City of Huron
Agenda for the Planning Commission/DRB
Wednesday, April 15 2026 5:00pm.

Cleveland Road E (Huron Harbor Development) PPN 42-61270.001
Variations to General Development Concept Plan

424 Berlin Road (Marconi's Restaurant) PPN 42-00321.000
Site & Design Plan approval- outdoor patio dining area & bar
- VI. **Staff Report**
Chapter 1129-Sign Code Amendment – Work Session TBD
- VII. **Other Matters**
Next Regular Meeting: May 20, 2026
- VIII. **Adjournment**

- Revised site plan

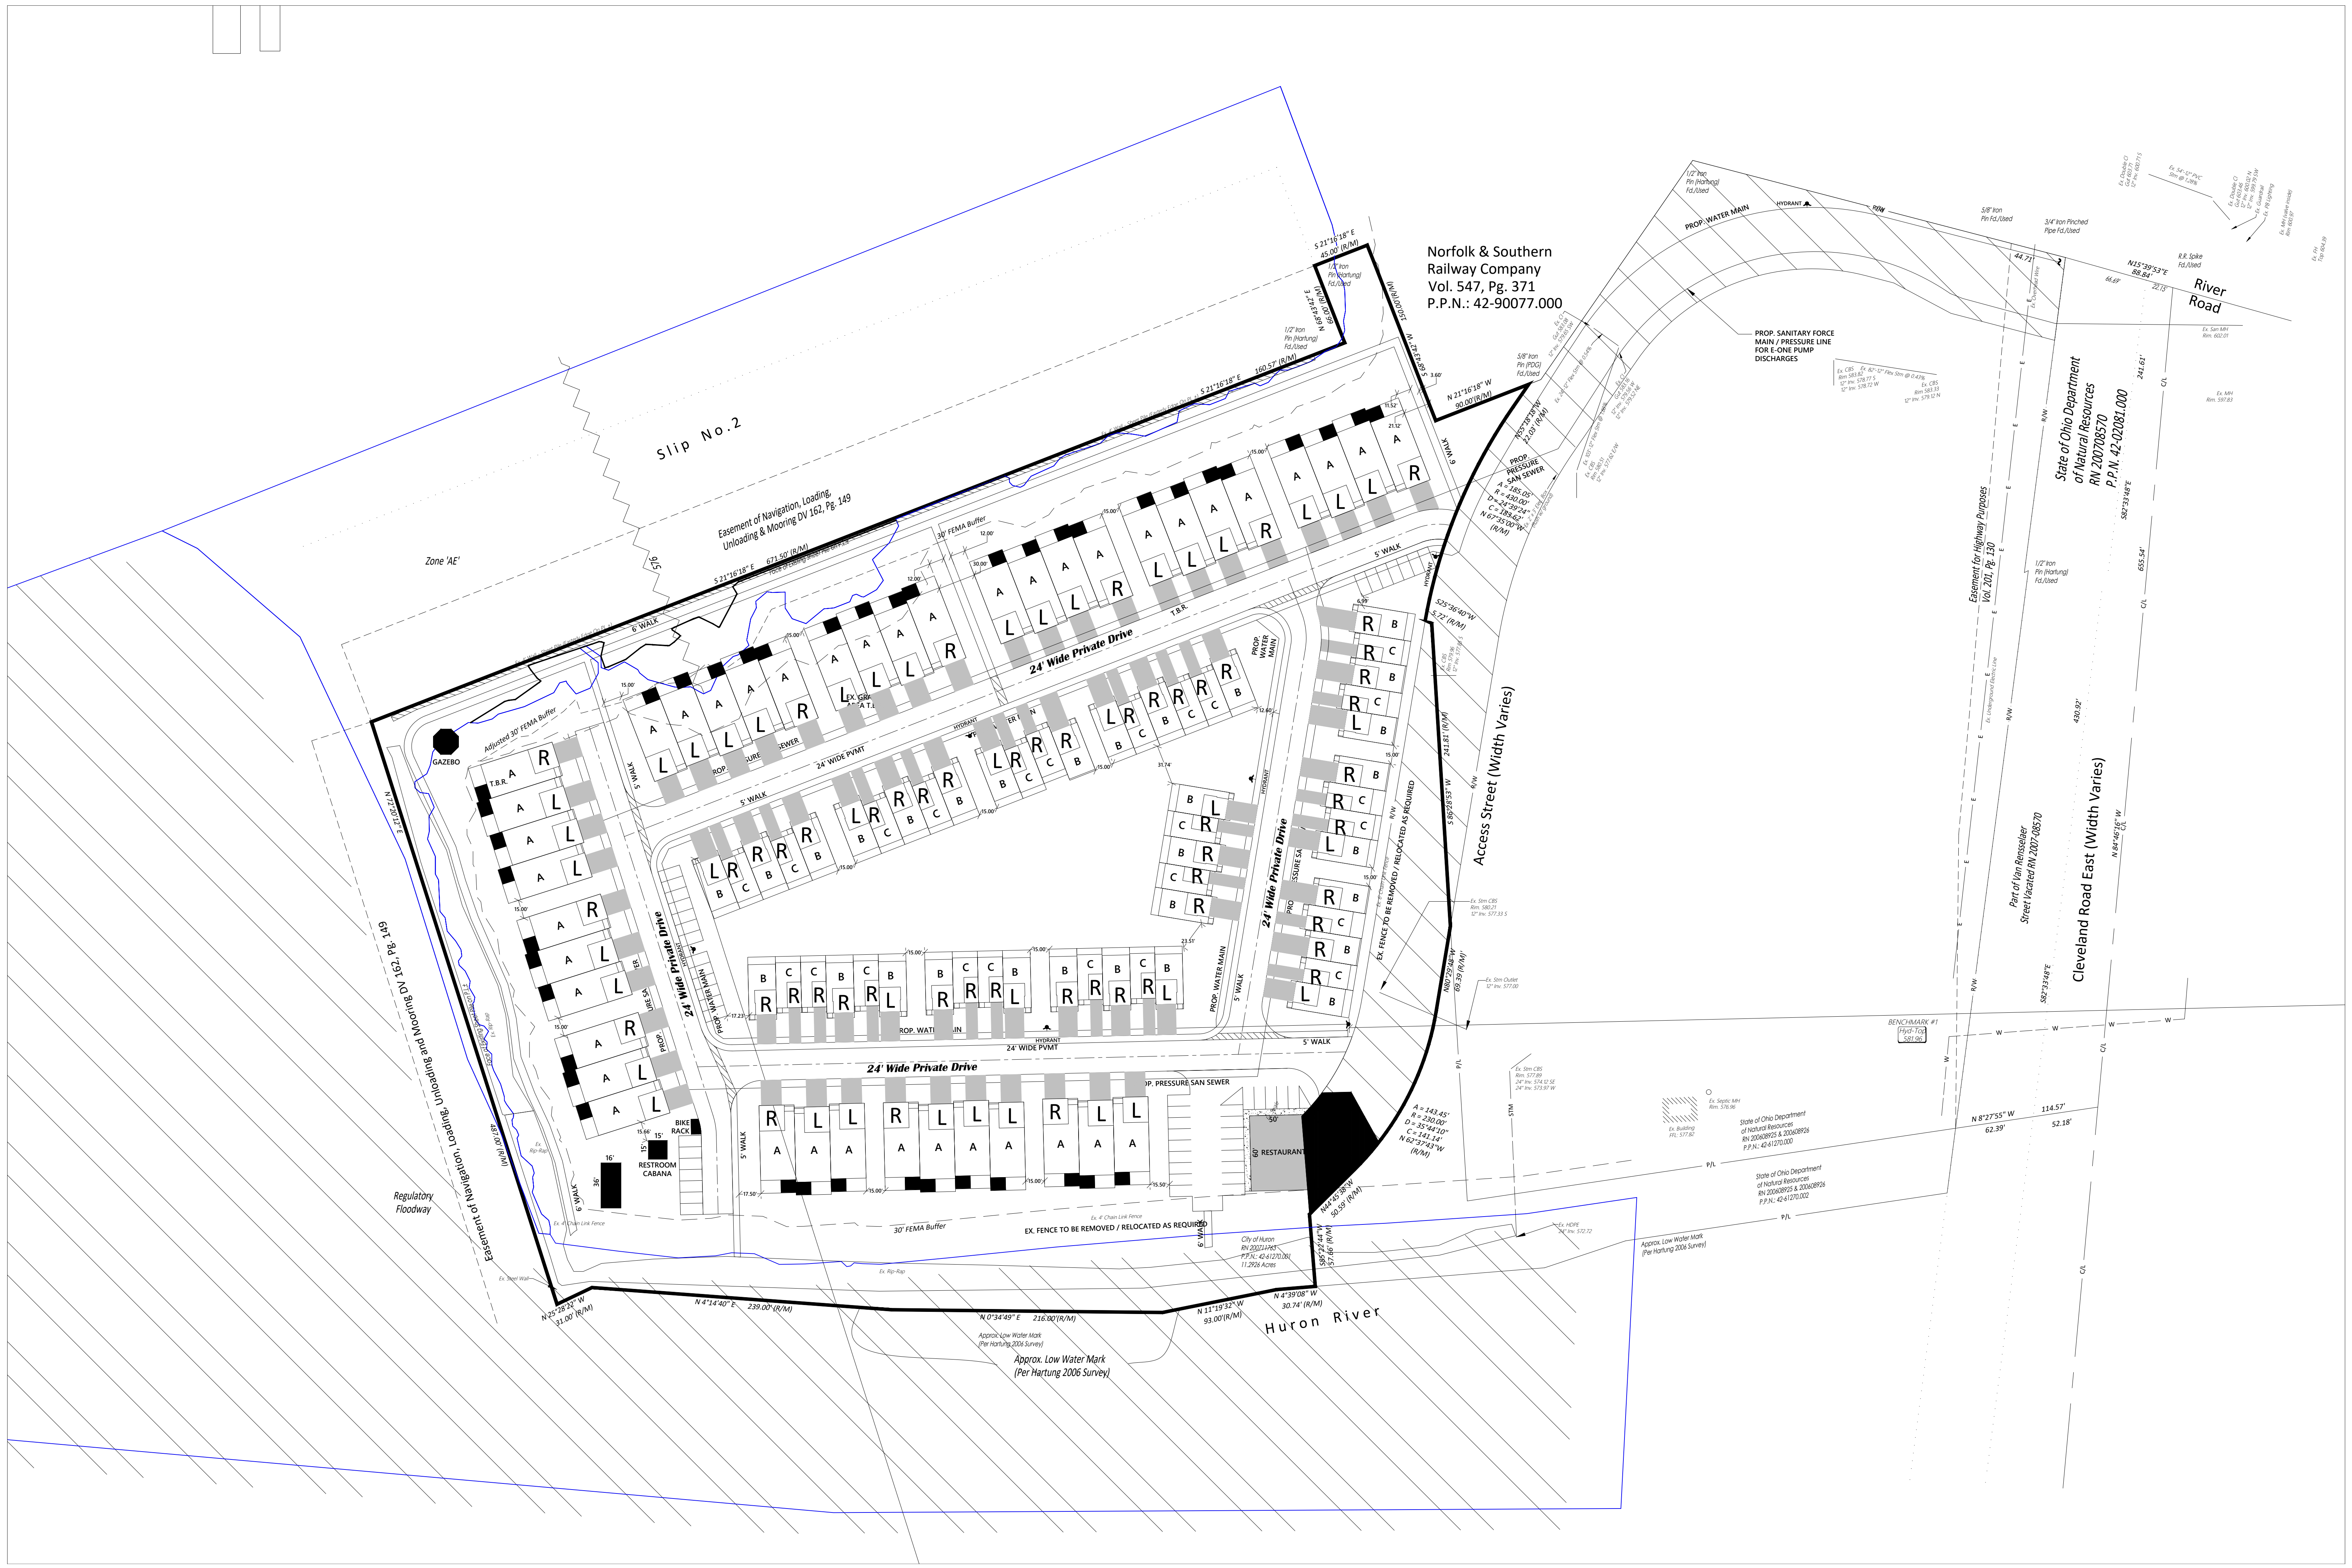
The city believes and supports that the variations regarding the minimal reduction to the number of townhome units from 106 to 95, the increase in width of the smallest unit from 16' to 20' and the inclusion of a 15' buffer between structures is in keeping with the spirit and overall concept of the General Development Concept Plan as the general layout of the development remains unchanged.

The city recommends Planning Commission approval of the variations pursuant to 1127.10 (b) which will allow the developer to commence with engineering, stormwater and SWPPP processes.

SITE PLAN

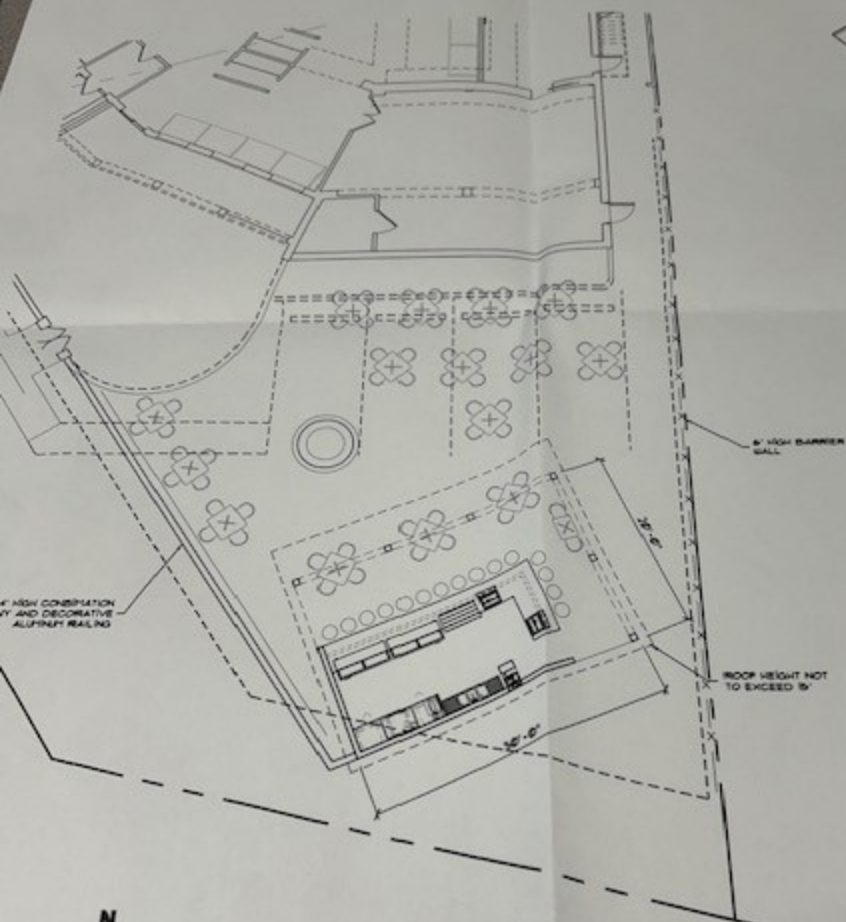
Pursuant to the B-3 code, the principal use is compliant to zoning, the accessory use (outside bar) would be compliant as a "structure customarily accessory and incidental to any of the foregoing permitted B-3 uses, and not otherwise prohibited"; proposed height of the outside bar is 15' which is compliant. There are not many Lot Area, Frontage, Yard Requirements in a B-3 – the only applicable requirement is having minimum frontage of 30' - which this parcel does have. There are no setback requirements for B-3. Staff consulted Safety Services and Administration as to the proposed location of the bar; staff is recommending the location of the bar be moved closer to the restaurant (6' separation) along the eastern side of the property.

The proposed masonry wall/fence surrounding this patio dining area is comprised of a short base wall topped with fence rails and will not exceed 4' in height, in compliance with the yard projection code. It is recommended that the height of the solid portion of the wall be limited to 2' or 3' to retain site line visibility. During our internal meeting, it was also noted that the wall/fence should be reinforced for the safety of the customers. It is important to note that one must pull past the stop bar currently in order to have site line visibility of the intersection area

This parcel abuts an R-1 parcel; there is an existing fence and an area of established trees/shrubs that separate the two parcels. The applicant was proposing a new 6' fence along the property line to act as a buffer in this area. With the unusual shape of the parcel and the angle of the restaurant and the location of the front entrance, staff is looking at this area as a side yard; however, the city feels the continuation of a 4' fence or wall/fence would be better suited for site line reasons.

- 1) Location of the proposed outside bar along the eastern side of the property, closer to the restaurant (at least 6' separation)
- 2) Limit the height of the solid wall/fence base to 2' or 3'
- 3) Include an opening to the patio area from the sidewalk that is at least 36" wide
- 4) Fencing and/or wall/fence to continue along the eastern side of the property- max height 4'
- 5) Fire pit feature is subject to Fire and Building Regulations.
